Title: **QUALITY AUDIT  
INCLUDING**

**Road Safety Audit, Access Audit, Cycle Audit and Walking  
Audit.**

**Stepaside Park Phase 3**

Report reference: **1507R01**

#### 3.1 Problem

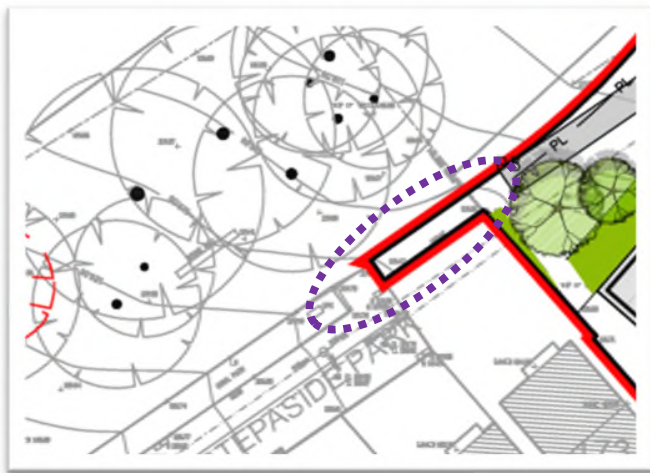
The proposed footpath link at the north eastern corner will have a discontinuity. This could lead to trips and falls.

It is recommended that the footpath be made continuous and that its effective width be made sufficiently wide to cater for the future demand. This may require the cutting back of the vegetation. The footpath link should also ensure that pedestrians do not conflict with turning vehicles in the hammer head.

### 3.2 Problem

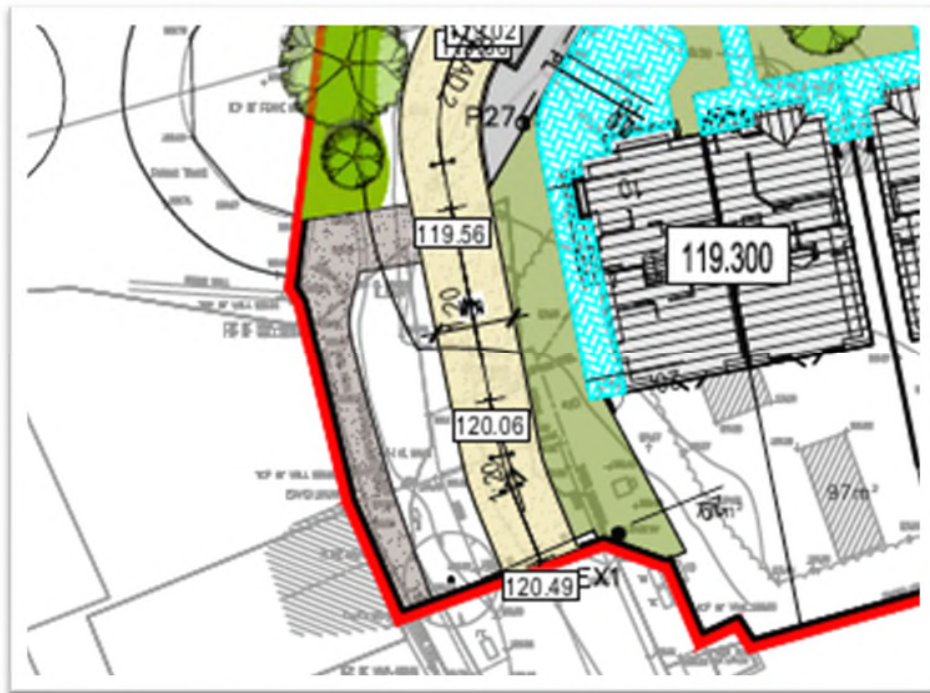
A short section of homezone is proposed at the connection to the existing road network. This will be a busy section of carriageway until the future Loop Road is constructed. The lack of segregated pedestrian areas at this point may increase the likelihood of a collision.

It is recommended that the segregated footpaths on both sides of the carriageway as per the existing cross section be maintained throughout this section.

Paragraph No. in Quality Audit Report	Problem accepted (yes/no)	Recommended measure accepted (yes/no)	Alternative measures (describe)	Alternative measures accepted by Auditors (Yes/No)
3.1	Y	Y		
3.2	N		This section in question is actually for pedestrians and cyclists. Removable bollards are going to be provided for emergency vehicle access only here over this short section	Yes
3.3	N		Removable bollards will be provided at the site boundary for emergency vehicle access. Pedestrian / cycle access is provide here in this shared zone	Yes
3.4	Y	Y		
3.5	Y	Y		
3.6	Y	Y
